ADDENDUM NO. 1

ATTACHMENT NO. 1: REPLACEMENT DRAWINGS

CONTRACT A
CANAL STREET
FLOOD MITIGATION PROJECT
SALEM, MASSACHUSETTS

C-101

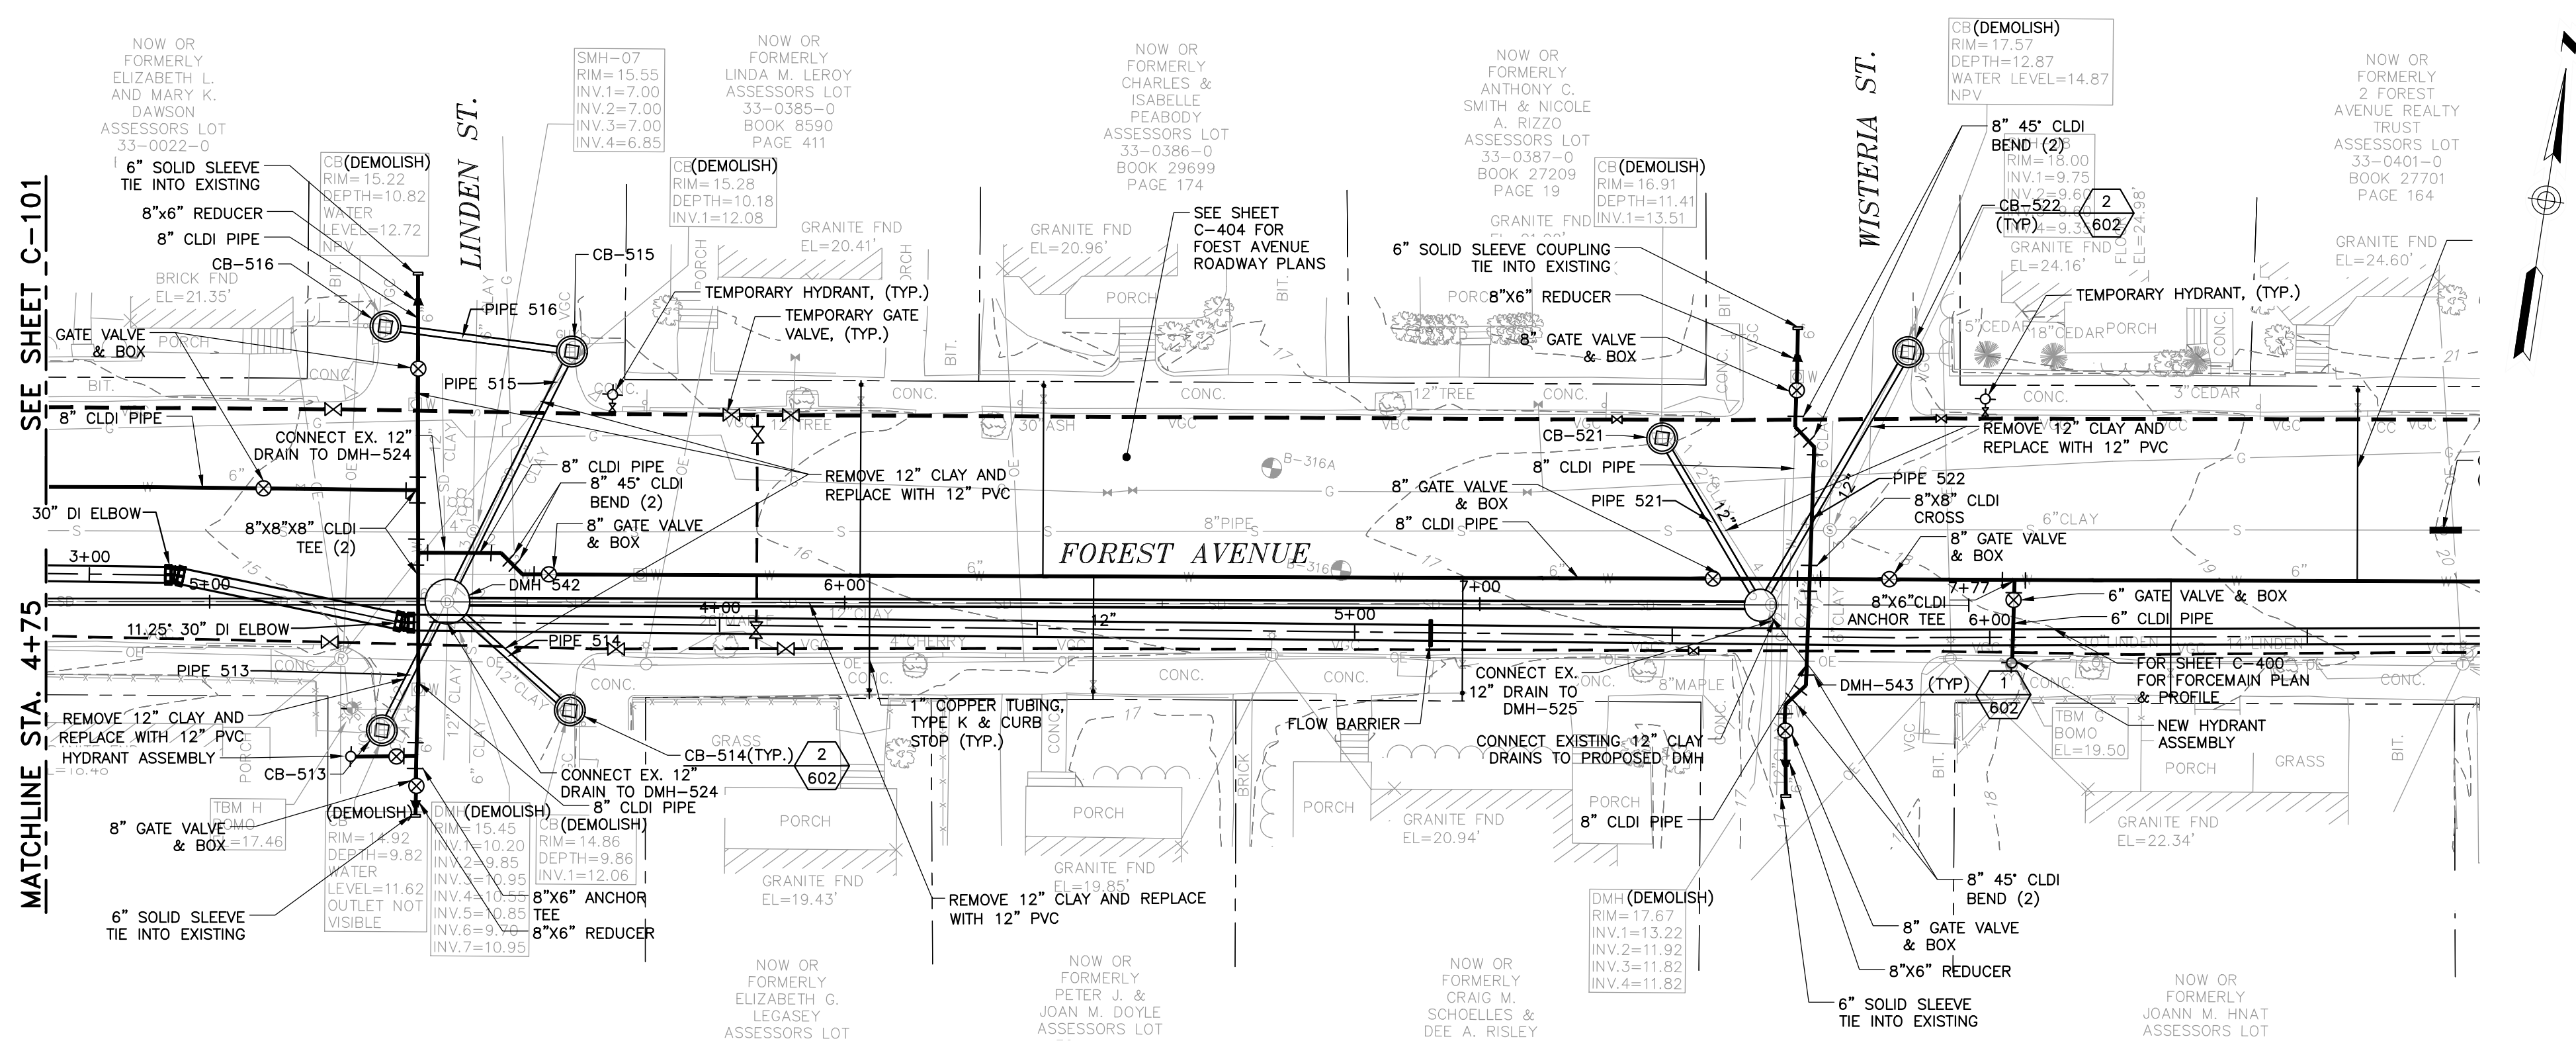
Question: On some of the Civil drawings (Sheets C-101, C-102, C-401, C-402, C-403, C-404), the vertical scale on the pipe profiles are labeled as 1"=5', but 1" does not line up with the 5' grid lines provided on the plans. Are we to use the grid lines or the scale as guidance? Please clarify how we are to determine the depths of the existing utilities that are shown on the profile (1"=5' or scale from grid lines).

Response: *The vertical scale should read 1" = 4'. New sheets will be provided*

C-505

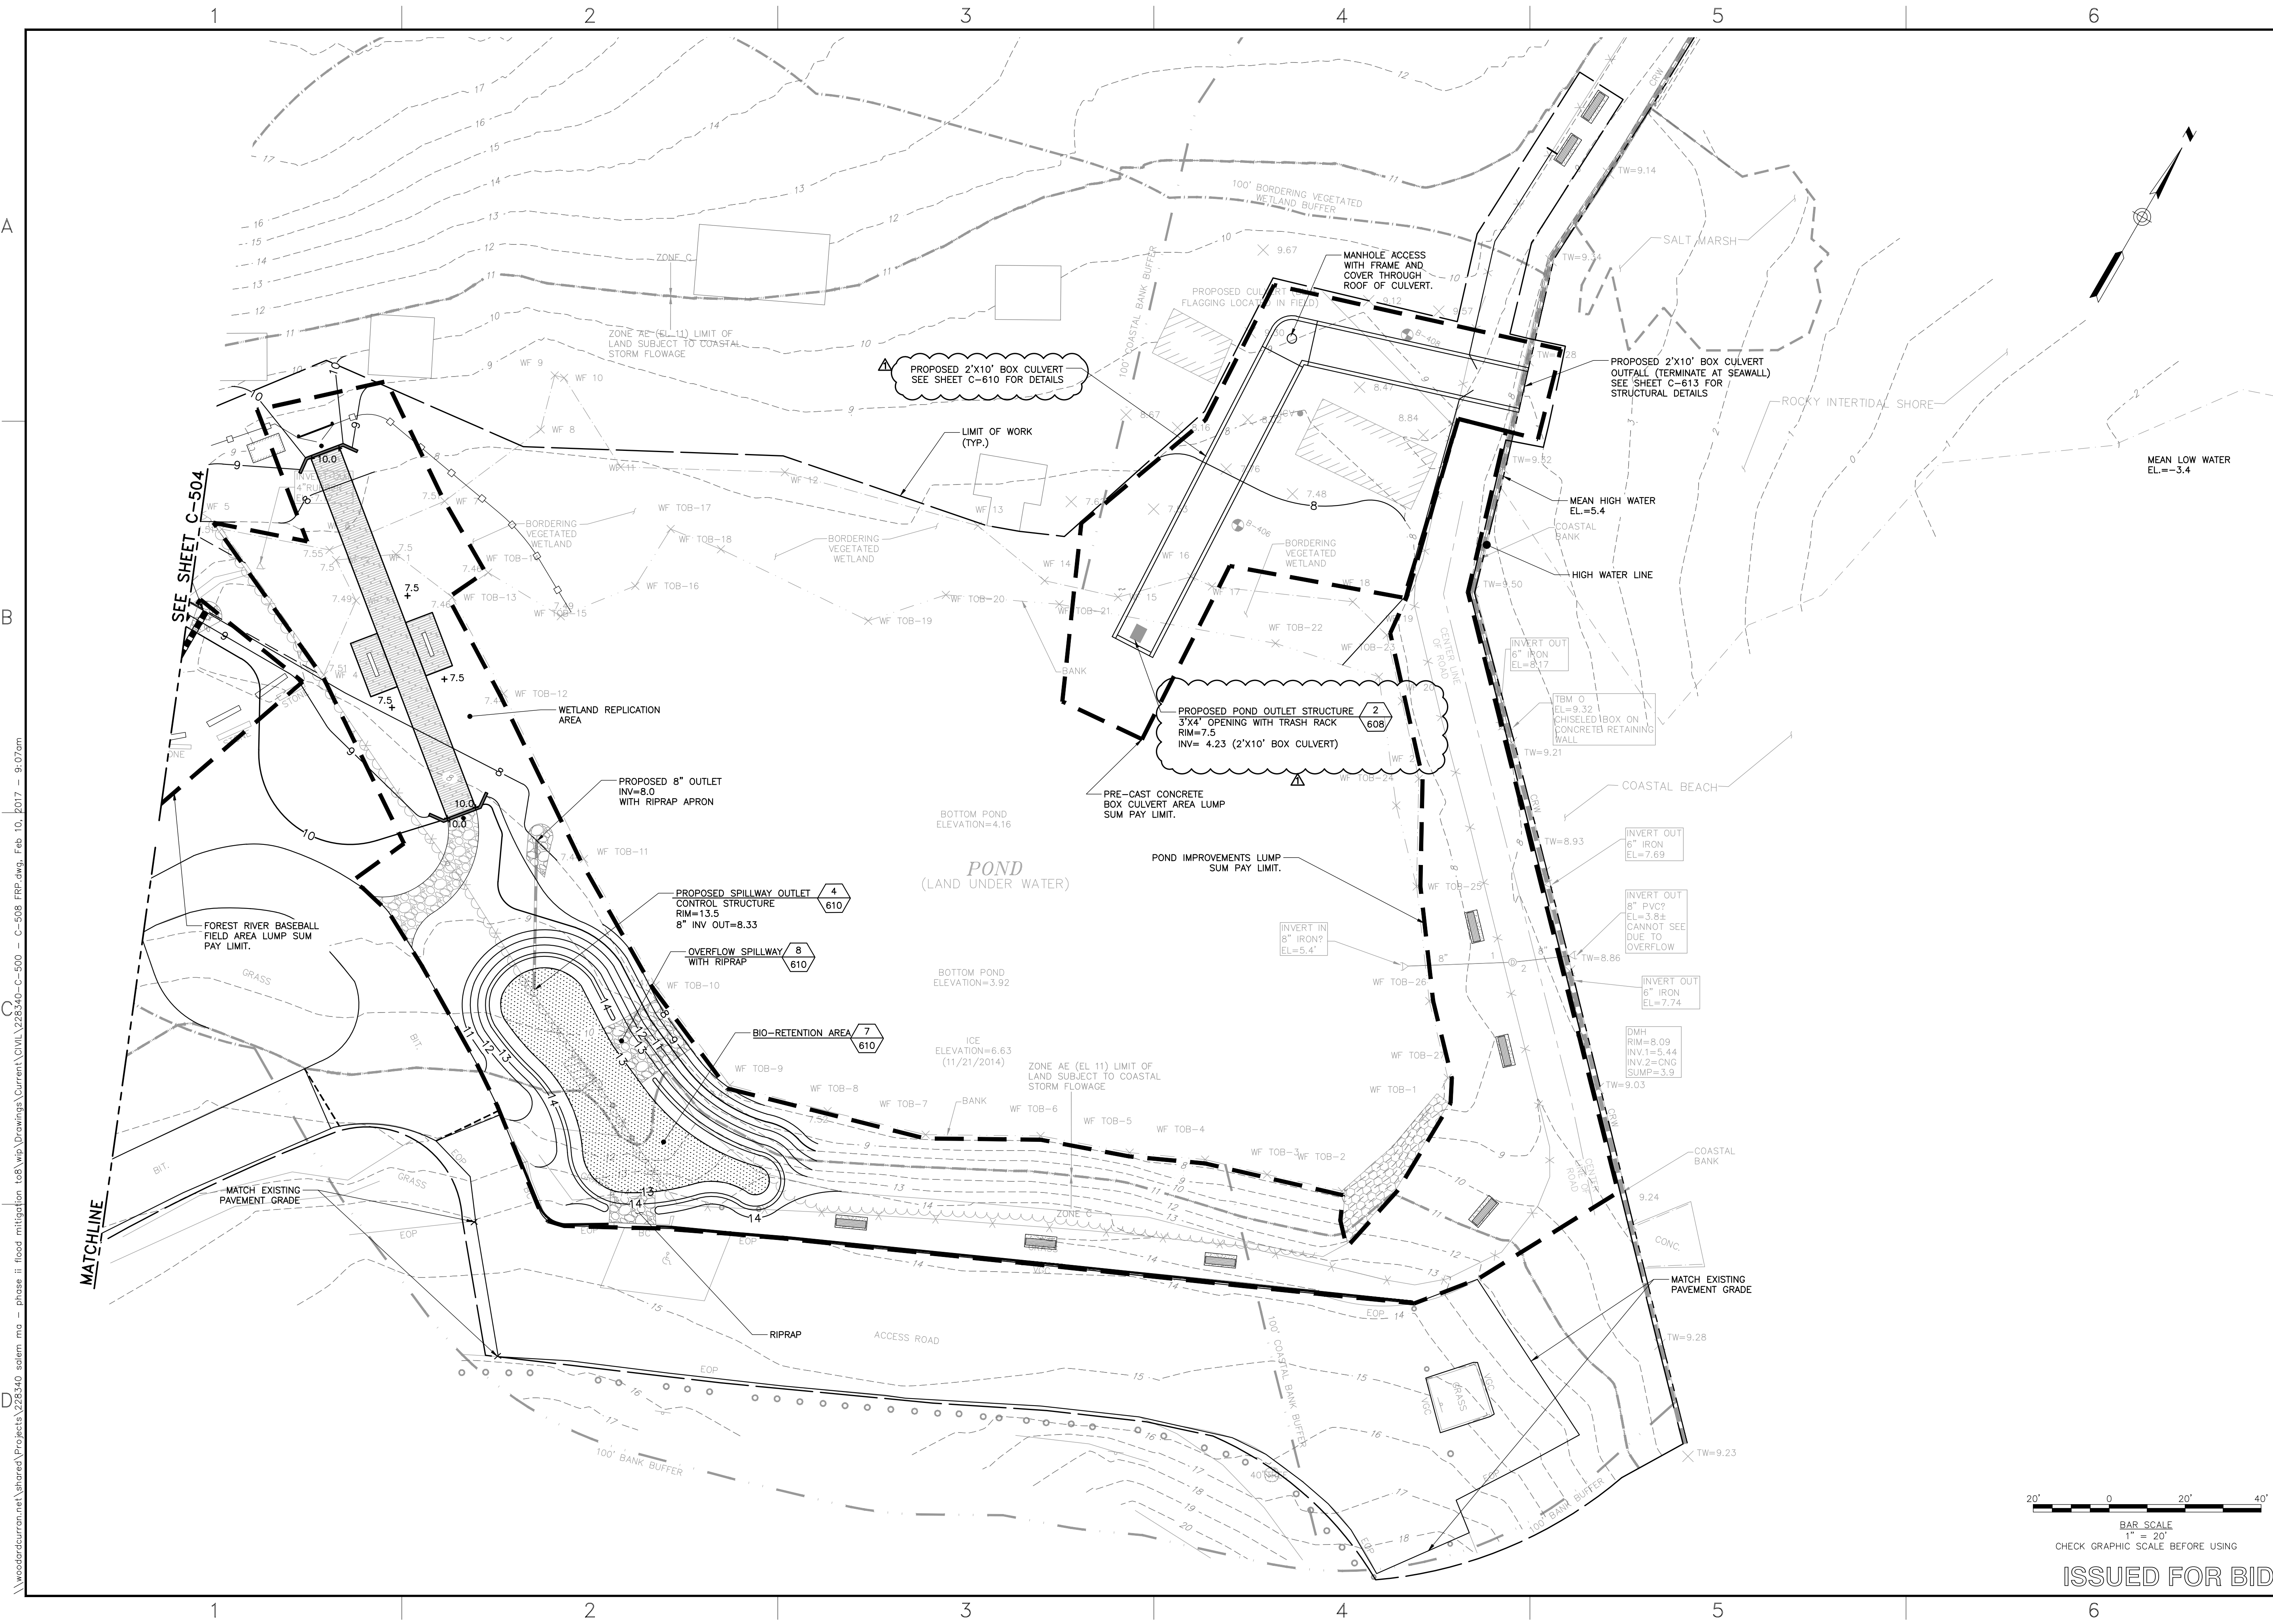
Question: Drawing C-505 – Box Culvert Seawall details Drawing C-613. Is the correct Drawing No. C-610?

Question: Drawing C-505 – Pond outlet structure details Drawing C-610. Is the correct Drawing C-608?

Response: *Yes, the correct drawing is C-610. Callouts on drawing C-505 have been updated.*

Response: *Yes, the correct drawing is C-608. Callouts on drawing C-505 have been updated.*

7 TRASH RACK

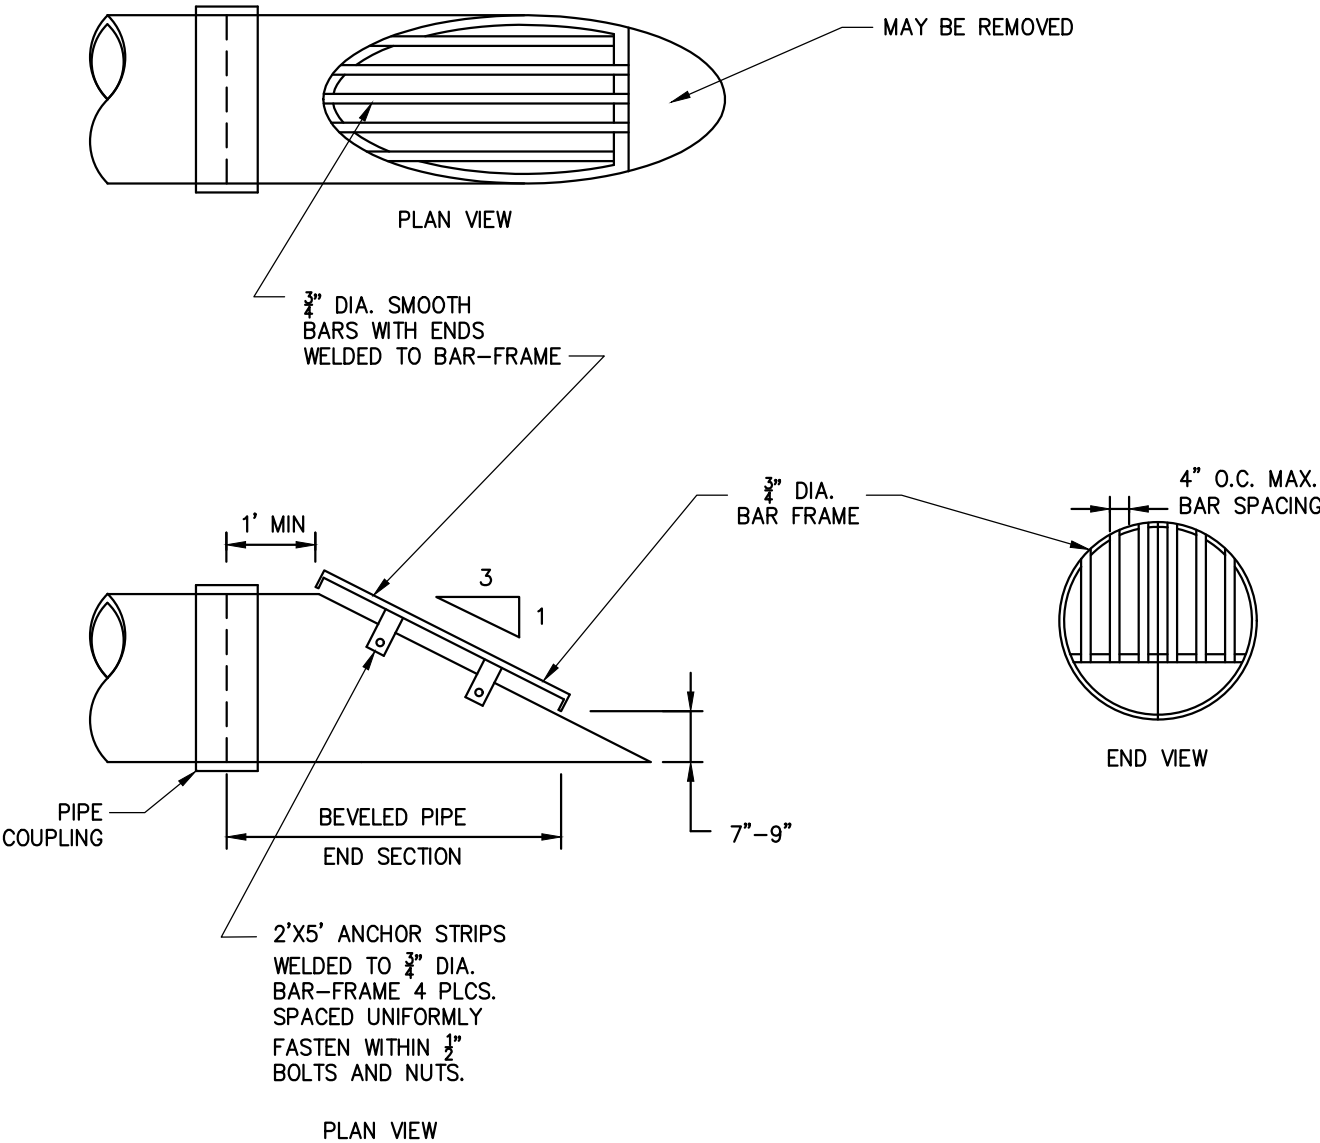
Question: Drawing C-404 – There are no details for the 42” RCP Trash Rack.

Response: *A detail for the trash rack has been provided on sheet C-609*
